**SAN RAFAEL HIGH SCHOOL**

**MASTER FACILITIES LONG-RANGE PLAN AND STADIUM PROJECT**

**FINAL ENVIRONMENTAL IMPACT REPORT**

**Subject: Comments on San Rafael High School Master Facilities Long-Range Plan and Stadium Project Draft Environmental Impact; 185 Mission Avenue; SCH # 2016082017; Case No. P16-005**

Figure 4..1-5

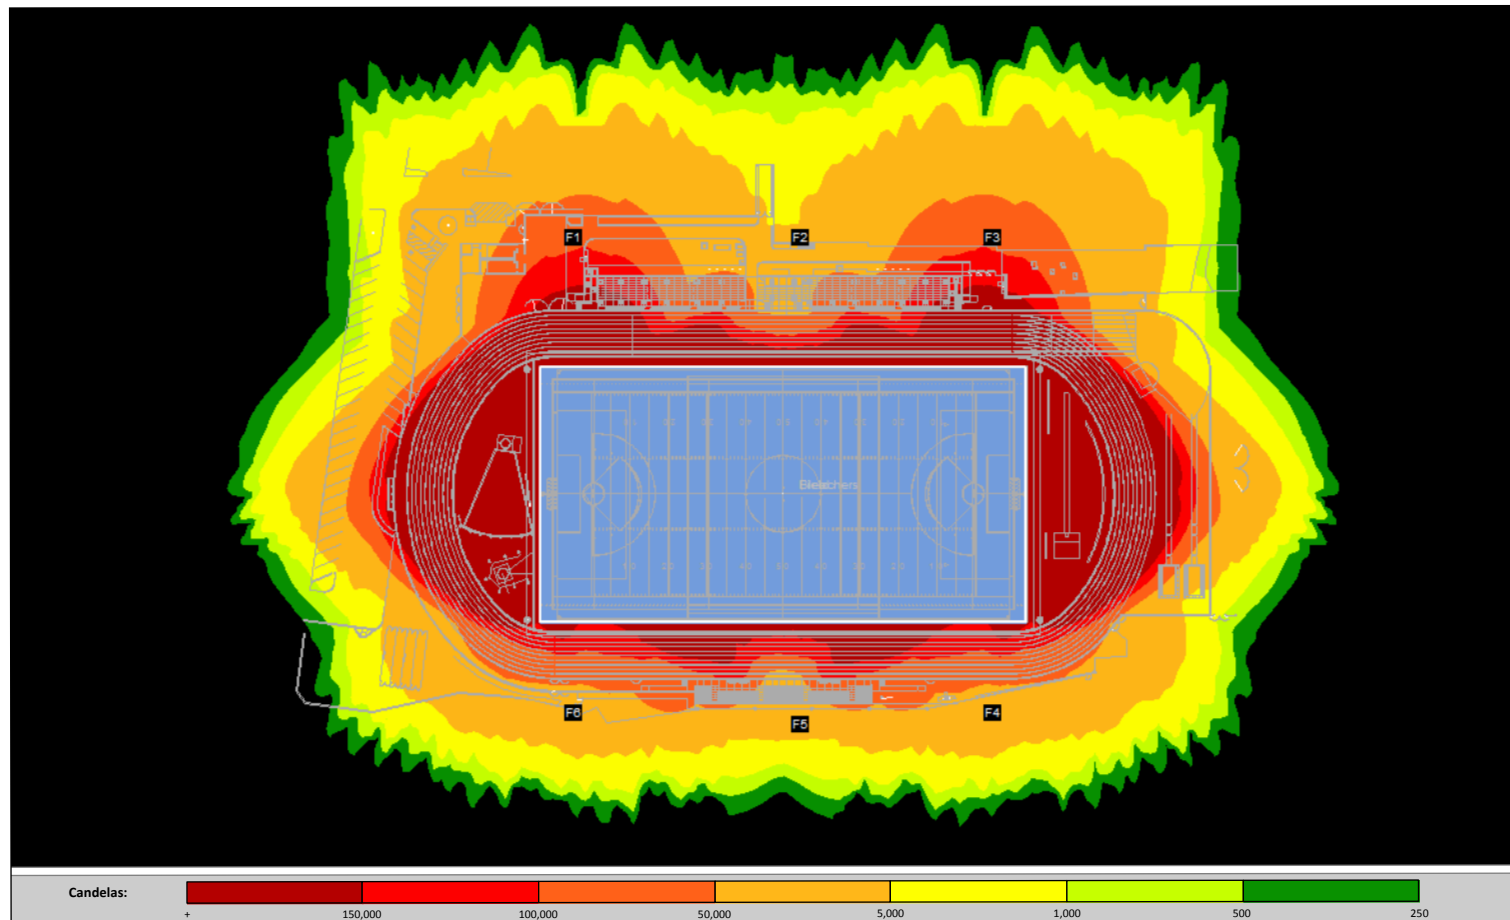
- B1-19 No specific measurements of light spillage, existing or proposed, were included in the DEIR, and such measurements are not required under CEQA. However, the District has worked to reduce the wattage of light fixtures, as shown in Table 3-2 on page 3-13 of the DEIR. Since preparation of the DEIR, the District's landscape consultant has provided a graphic showing lighting intensity at the proposed Stadium Project, and this graphic is now included as a new Figure 4.1-5 and is shown in Chapter III of this document. The lights that would have motion sensors would be limited to path lights and parking lot lights. The parking lot and entry area would have pole lights to provide necessary illumination to see signage and markings on pavement. LED light color can be specified as "arm" 3000kelvin if desired, so as to minimize blue content. Figure 3-6 of the DEIR shows the new lighting posts as number "4" in the graphic. Six light poles are shown. Please also see discussion of Impact AESTHETICS-3 and Mitigation Measure AESTHETICS-3 on pages 4.1-14 and 4.1-15 of the DEIR.

Figure 4.1-5, shown on the following page, is a new graphic provided to show lighting intensity at the proposed Stadium Project.

Figure 4.12-3A

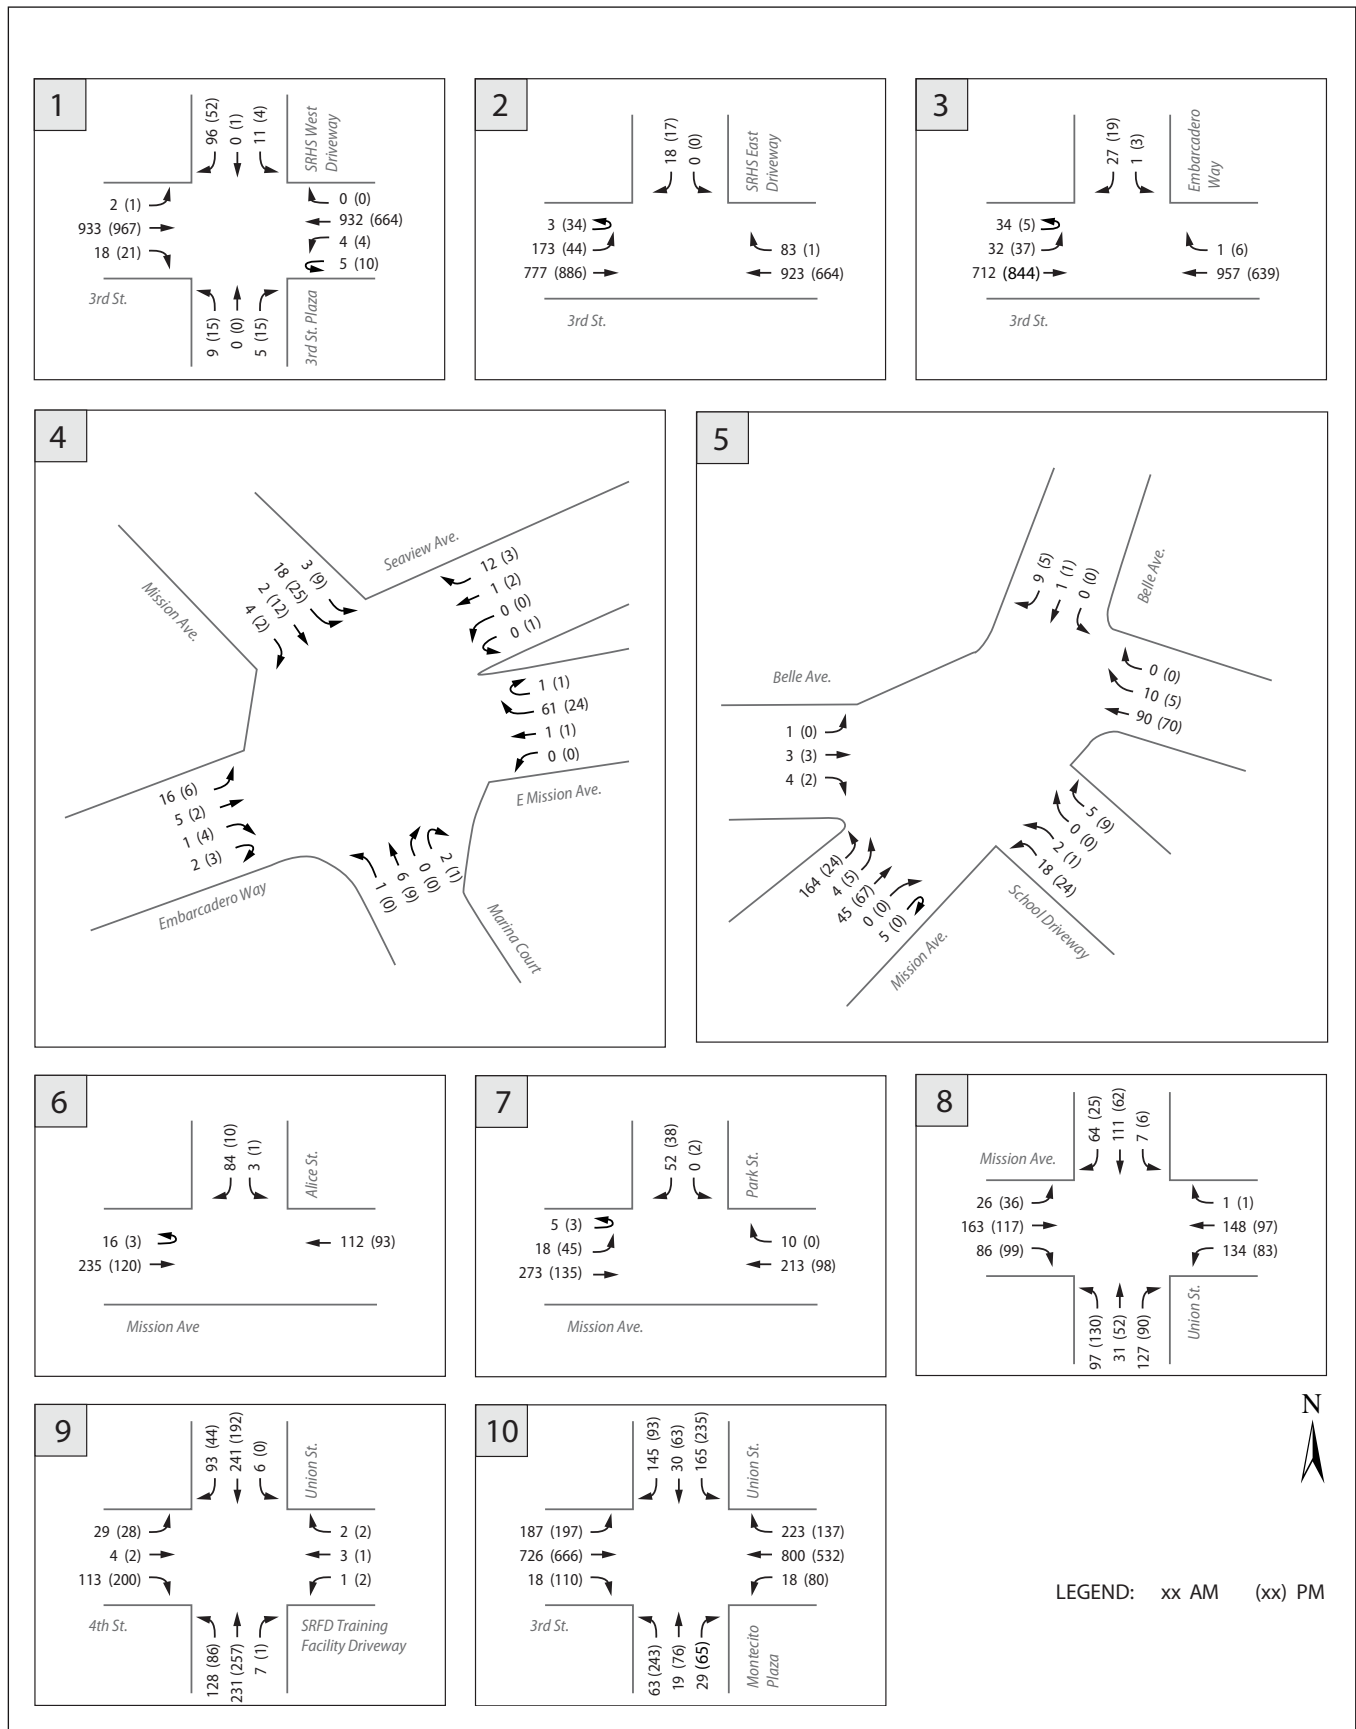
Page 4.12.25 (Figure 4-12-3A)

- A1-22 Comment noted. The referenced trip numbers in Figure 4-12-3A are typos. The figure has been revised to reflect 844 eastbound through trips during the evening peak hour at 3<sup>rd</sup> Street/Embarcadero Way and 65 northbound right-turn trips at the 3<sup>rd</sup> Street/Union Street intersection as shown in Chapter III..

Page 4.12-25, Figure 4.12-3A, is modified as shown on the following page.
